Re: DIR-2019-1115-CDP-MEL-1A, et al. // CEQA No. ENV-2019-1116-CE
Address: 17440-17444 West Castellammare Drive

WLAAPC Meeting December 1, 2021: Supplemental Submission for Item # 7 and 8: Planning Case No. AA-2018-3776-PMLA-SL-1A, ZA-2018-3779-ZAA-1A, ADM-2018-3775-SLD and ENV-2018-3779-1A

West Los Angeles Area Planning Commission – December 1, 2021 – Agenda items #7 and 8
Appeal Supplemental Submission

West Los Angeles Area Planning Commission – December 1, 2021 – Agenda items #7 and #8
Day-of-Appeal Submission

3) Case No ZA-2005-2144 (ZV) – 1251 Appleton Way

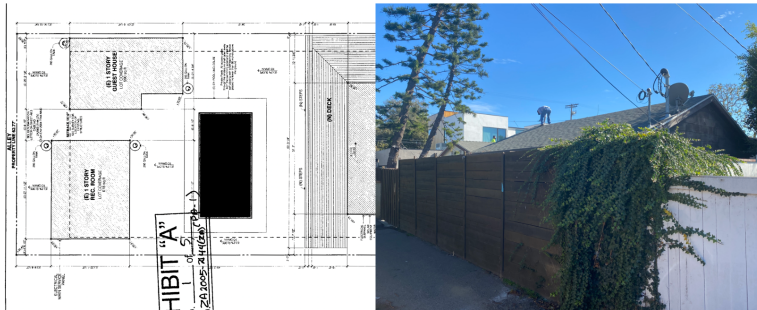
1. Year Approved: 2005
2. **This is a Variance** not an Adjustment: findings must have proven hardship
3. Single Family Zone Property = R1-1VLD Zone
4. Zoning Variances Granted:
 - a. 6-inch easterly setback for (E) 2nd dwelling in – one- story high
 - b. Zero westerly setback for (E) Pool Equipment
 - c. 9-foot separation between (E) 2nd dwelling and (E) Red Room
5. All the structures are existing and to remain, the non- complying structures are one-story buildings
6. **This is a case of recording an existing, non-conforming setback and building separation**

5) Case No ZA-2003-0424 (ZV)(ZAA) – 1157 Palms

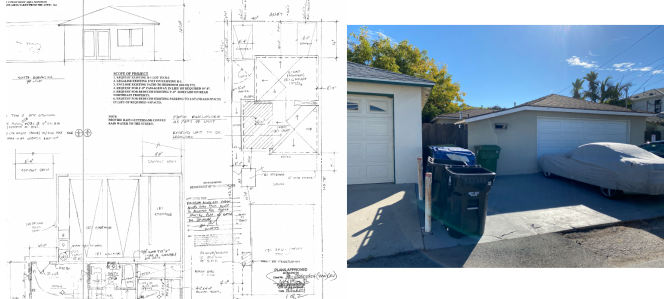
1. Year Approved: 2003
2. This case involved a Variance and an Adjustment, the Variance findings must have proven hardship
3. Single Family Zone Property = R1-1VLD Zone
4. Zoning Adjustment:
 - a. 2-feet easterly side setback for (E) 2nd dwelling unit – one-story (12 feet high)
5. **This is another case of recording a non-conforming setback and building separation**

SHEET
1
OF 1

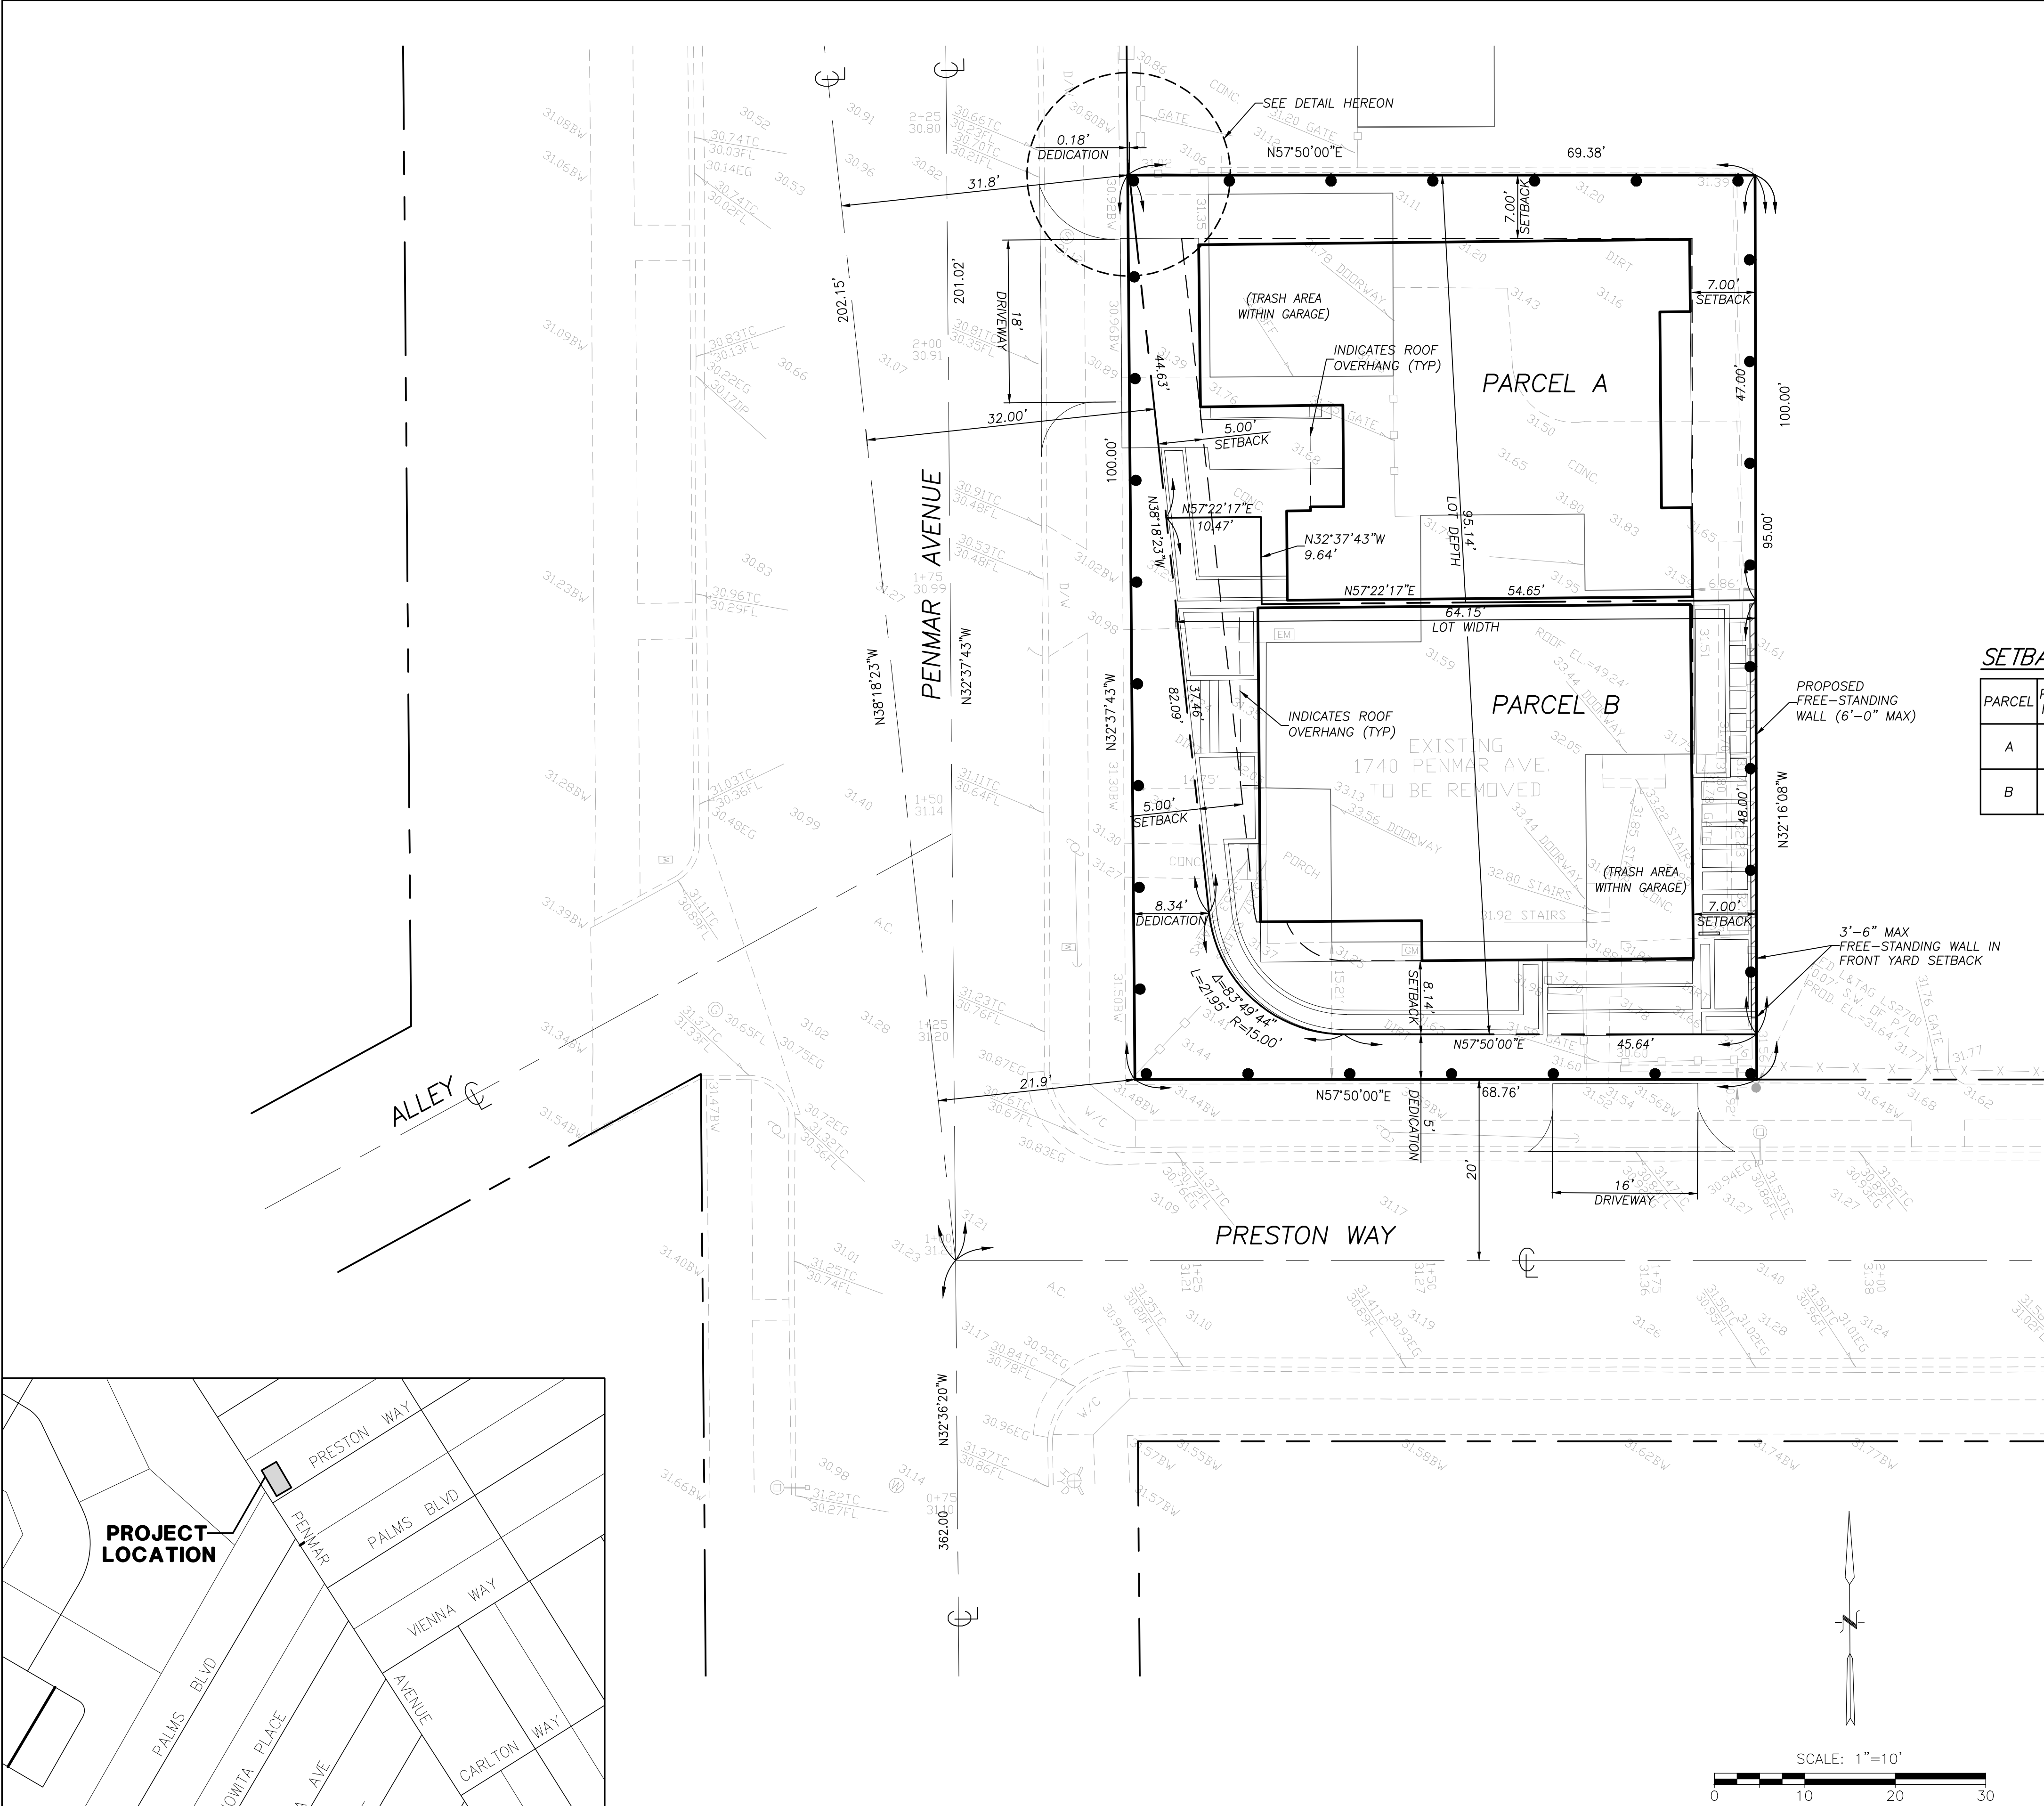
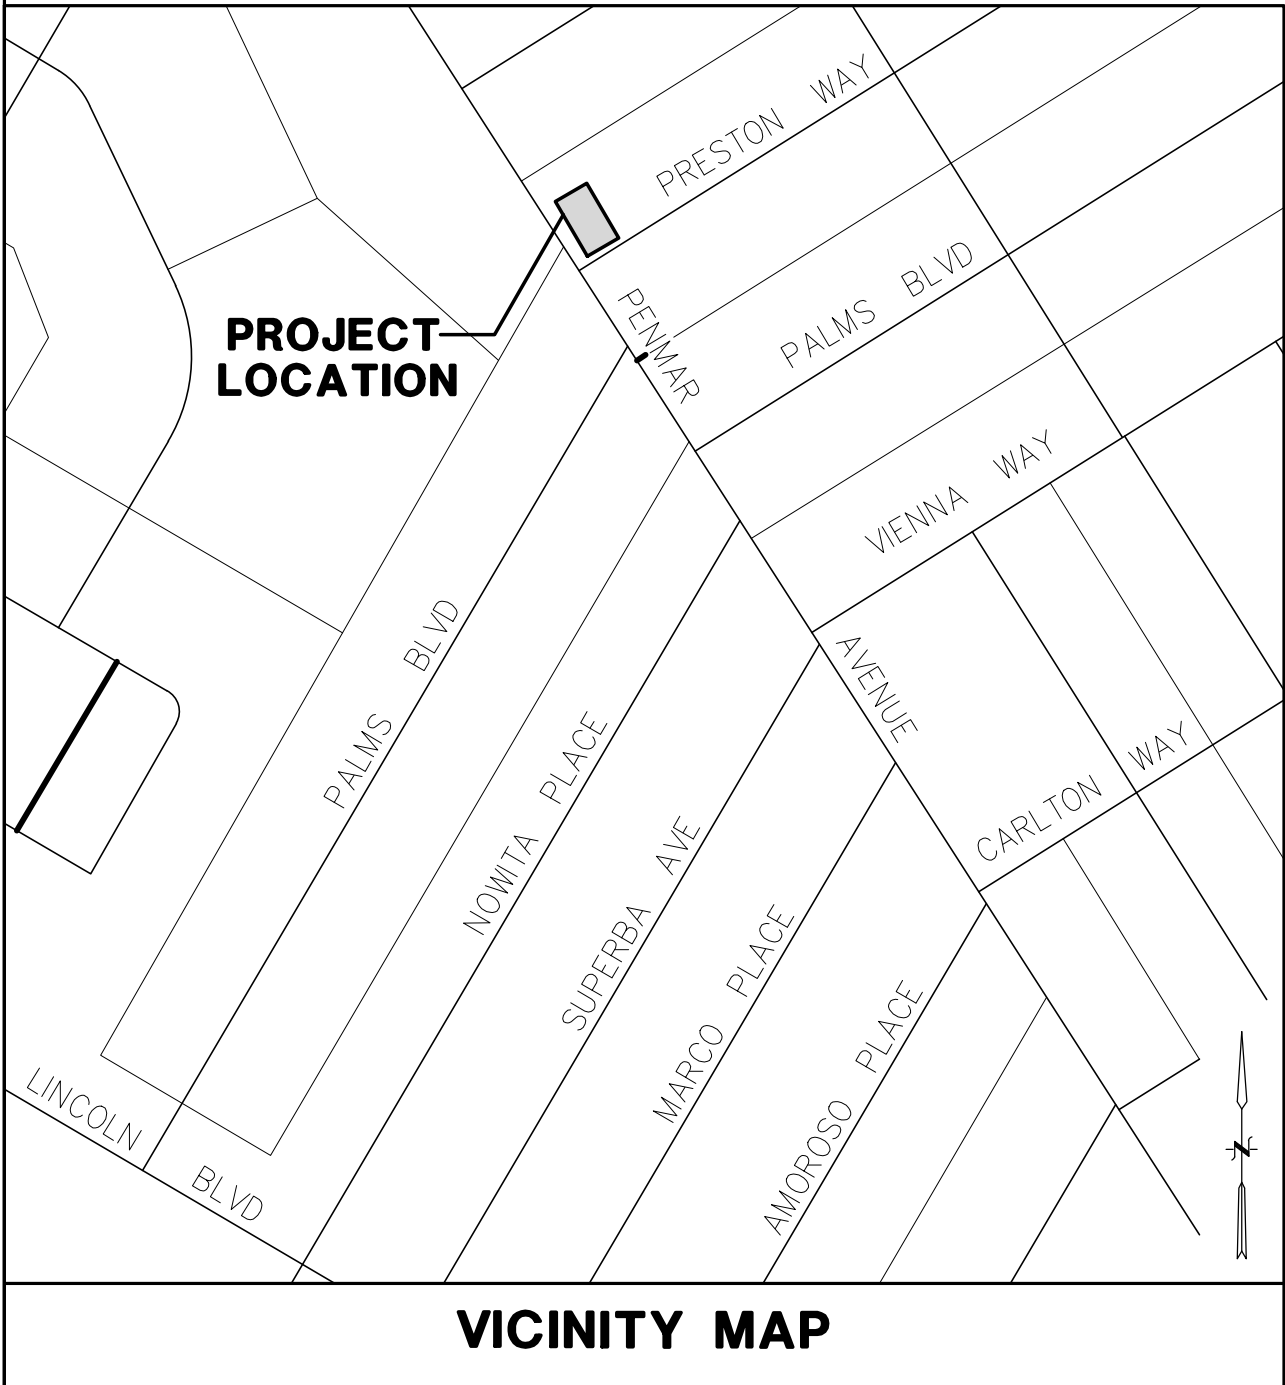
Apologies, the Site Plan needed to be slightly updated to match the Parcel Map - the only correction was an inch reduction in the FYSB off of Preston from 8'-2" to 8'-1". Please see attached revised Site Plan and Secondary Submission to reflect this very small change.

Please see attached revised site plan and Parcel Map that shows further increases in the setbacks from the neighbors. This did necessitate a further reduction in the FYSB along Preston however (see below). I'm still working on the presentation and will share it next week.
